Technical Service Bulletin: TSB240007

Released Date: 17-Dec-2024

Camshaft Thrust Plate Installation

Figure 1, Factory Step 3 Exploded Diagram.

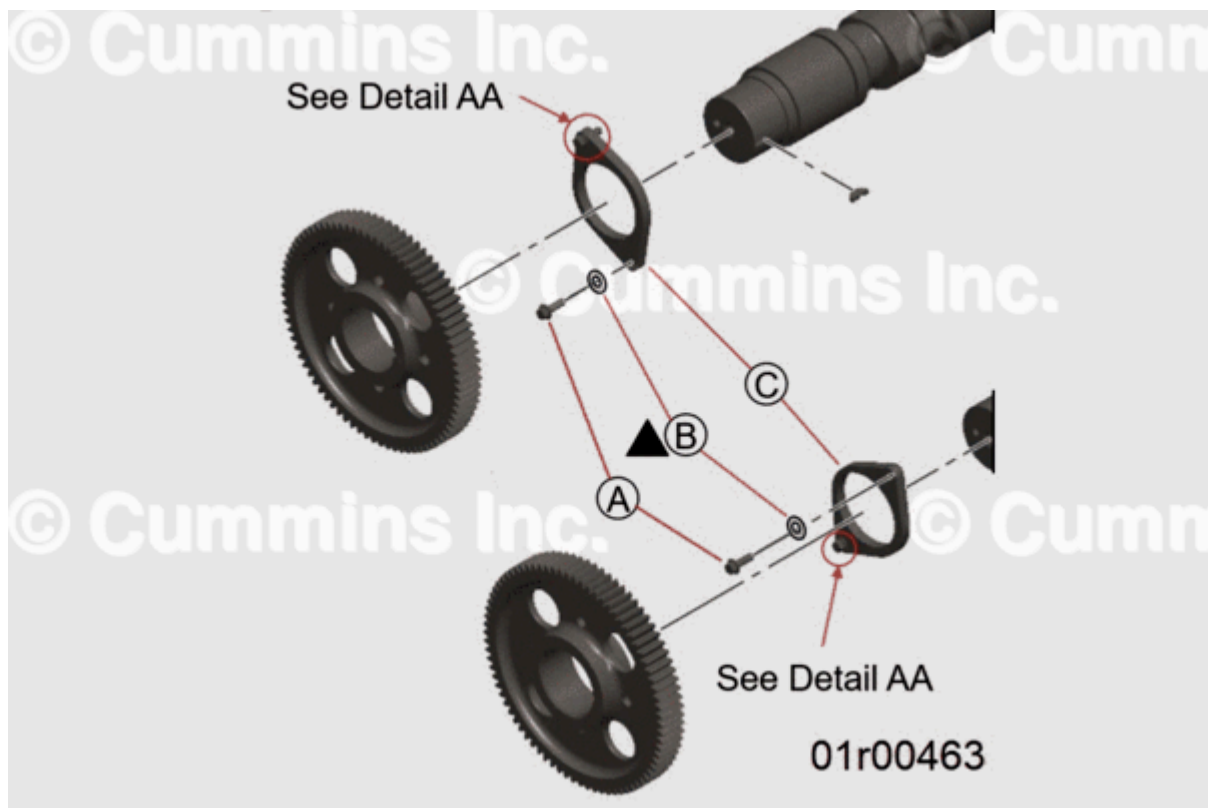
Washer listed in Table 1 and Item B within Figure 1 **must** be used with the existing capscrews, and in the specified orientation, when installing new camshaft thrust plates.

Factory step 3 action has been implemented to address under head embedment of the bolts in the camshaft thrust plate material. Installation of the washers should be targeted in a fix as fail situation or at a scheduled rebuild interval.

Figure 2, Detail AA Showing Correct Washer Orientation at Installation.

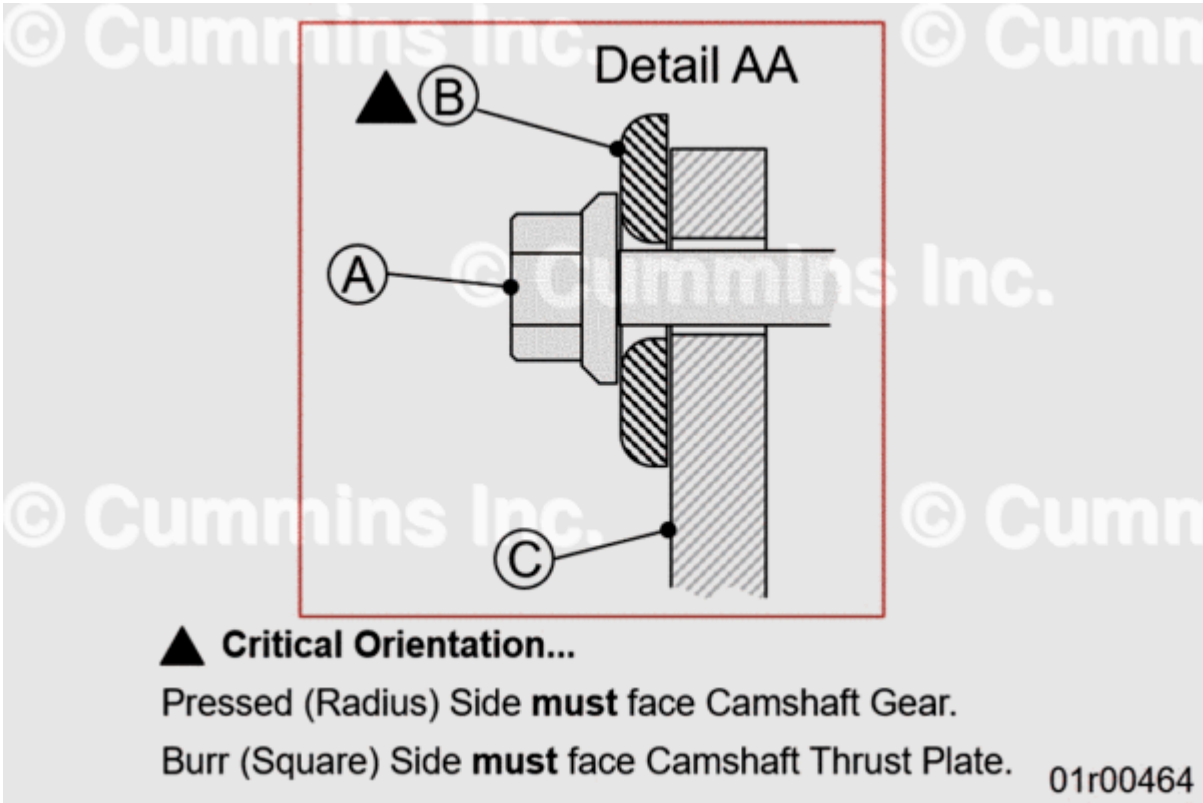
- The washer orientation is critical.
- There are two different faces to the washer; see Figure 2.
 - The pressed face edges will appear radiused or rounded in appearance.
 - The burr face edges will appear squarer in appearance.
- The burr face **must** be facing the camshaft thrust bearing plate during installation. Testing showed that incorrect orientation of the washer will result in a poor joint and embedment of a different form in the camshaft thrust plate material.
